SUBJECT: ST. LUCIE UNIT 1 - ISSUANCE OF AMENDMENT RE: BORIC ACID MAKEUP SYSTEM (TAC NO. 67051)

FLORIDA POWER & LIGHT COMPANY
DOCKET NO. 50-335
ST. LUCIE PLANT UNIT NO. 1
AMENDMENT TO FACILITY OPERATING LICENSE

Amendment No. 94
License No. DPR-67

SAFETY EVALUATION BY THE OFFICE OF NUCLEAR REACTOR REGULATION

FIGURE 3.1-1 ST.LUCIE 1 MIN BAMT VOLUME

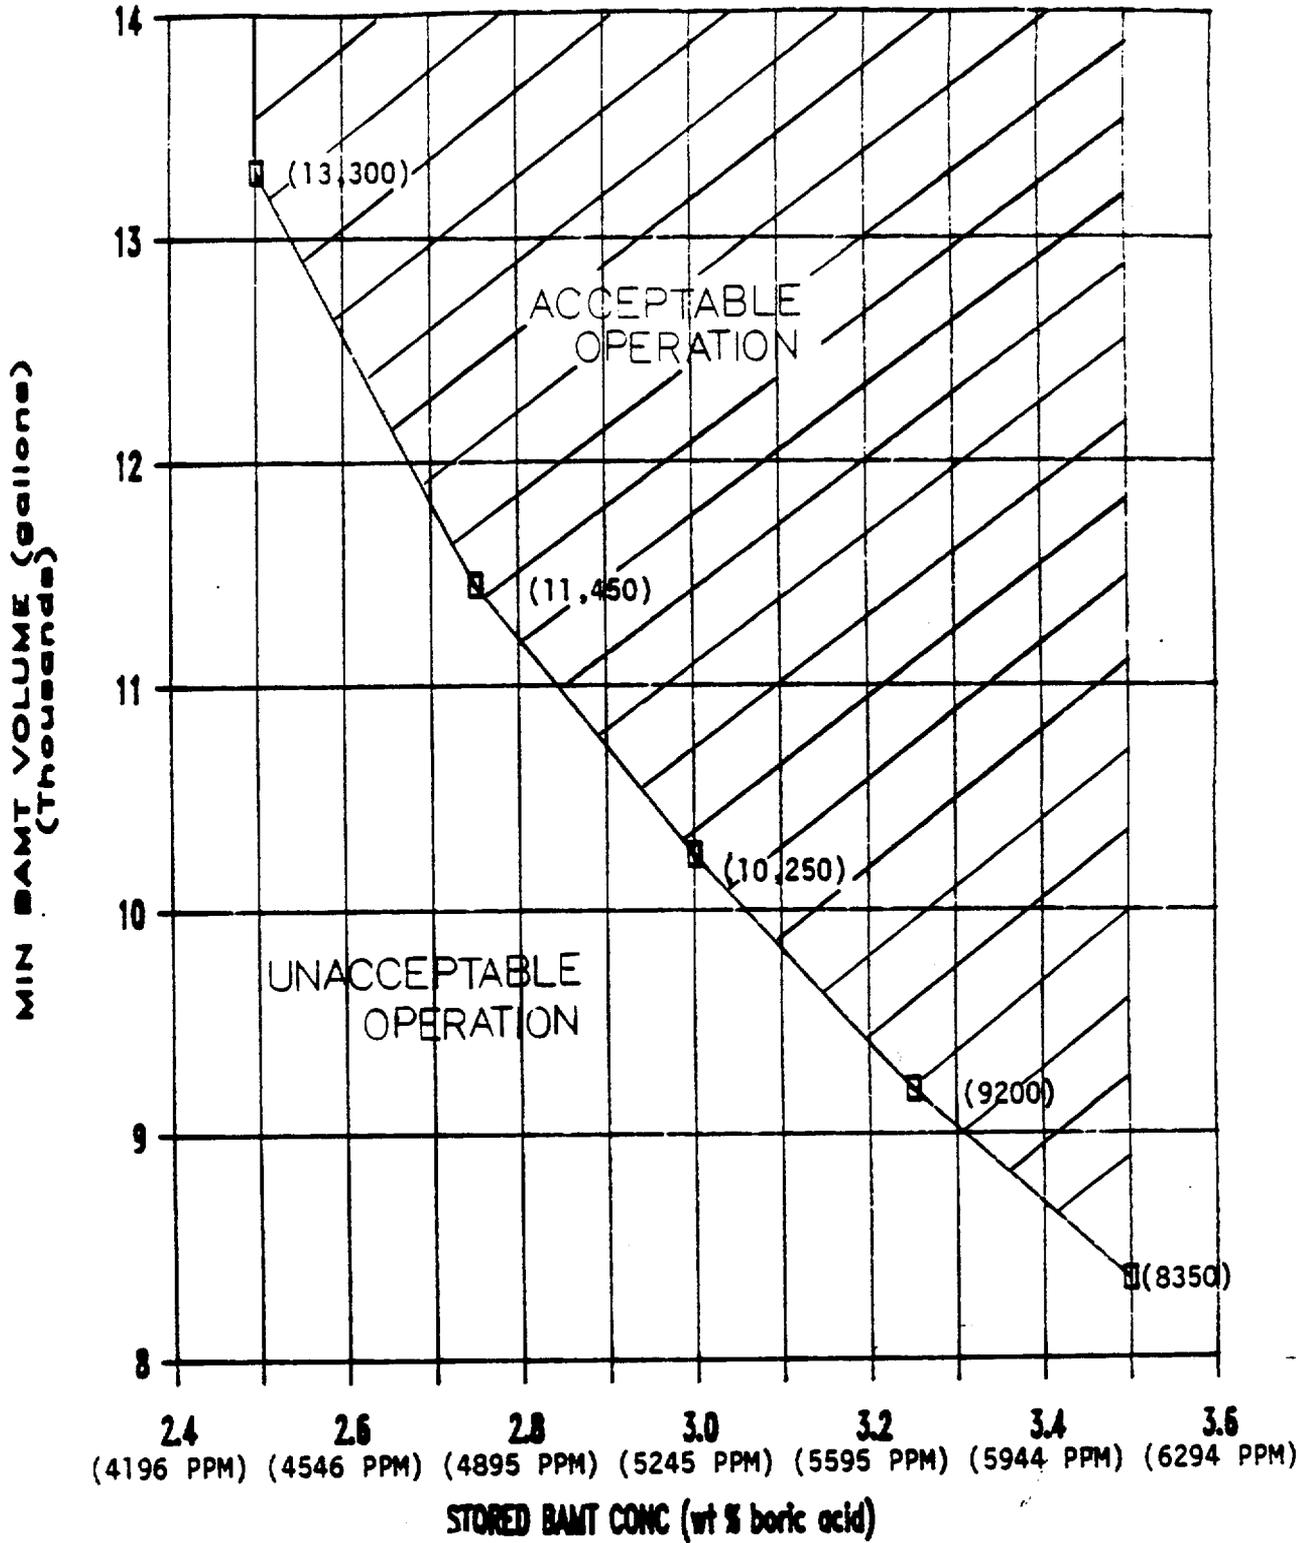
Figure 3.1-1 (for Operating Modes 1 through 4)

The existing figure specifies the minimum required BAMU water volume and temperature as a function of stored boric acid concentration for the various plant operating modes. The existing figure is applicable to any one of the two BAMU tanks, each having a maximum capacity of 9700 gallons (only 9450 gallons assumed to be useable). The revised figure specifies the minimum required water volume (contained in one or both BAMU tanks) as a function of boric acid concentration in the BAMU tank. This curve was generated in report CEN-353(F) for a minimum refueling water tank boron concentration of 1720 ppm boron. This curve conservatively bounds BAMU tank minimum required water volumes for conditions when the refueling water tank boron concentration is greater than 1720 ppm (a Technical Specification requirement). The range of

boron concentration in the BAMU tank will be reduced from 8.0 to 12.0 weight percent boric acid to 2.5 to 3.5 weight percent. The upper range of the required borated water volume will increase from 7,900 gallons (8 weight percent) to 13,300 gallons (2.5 weight percent). The lower range of the required borated water volume will increase from 6,600 gallons (12 weight percent) to 8,350 gallons (3.5 weight percent). The revised Figure 3.1-1 is consistent with the analytical results of CEN-353(F) for plant conditions at Operating Modes 1 through 4 to maintain the required safe shutdown margin. The temperature versus BAMT concentration curve has been removed from the Technical Specifications since it is no longer required. The revised figure is acceptable.

The existing Figure 3.1-1 specifies the volume of boric acid of 7,900 gallons at a minimum concentration of 8.0 weight percent to be maintained in the BAMU tank. The proposed changes are to provide a new range of boric acid concentration of 2.5 to 3.5 weight percent for one or both of the BAMU tanks. The revised volumes of Figure 3.1-1 raise the minimum water volume to 8,350 gallons. Deletion of the requirement to heat trace the BAMU system is consistent with the ability to maintain 2.5 to 3.5 weight percent boric acid in solution at temperatures above 50°F. The revised surveillance requirements delete verifying the BAMU tank temperature unless the auxiliary building temperature is below 55°F. For conservatism, this verification of temperature is done more frequently (24 hours versus 7 days) and the old surveillance requirement has been deleted.

- a. Boric Acid Makeup Tank 1A in accordance with Figure 3.1-1 and in the range of 3.2 to 3.5 weight percent boric acid (5595 to 6119 ppm boron).
- b. Boric Acid Makeup Tank 1B in accordance with Figure 3.1-1 and in the range of 3.2 to 3.5 weight percent boric acid (5595 to 6119 ppm boron).
- c. Boric Acid Makeup Tanks 1A and 1B with a minimum combined contained borated water volume in accordance with Figure 3.1-1.
- d. The refueling water tank with:
 1. A minimum contained volume of 401,800 gallons of water,
 2. A minimum boron concentration of 1720 ppm,
 3. A maximum solution temperature of 100°F,
 4. A minimum solution temperature of 55°F when in MODES 1 and 2, and
 5. A minimum solution temperature of 40°F when in MODES 3 and 4.
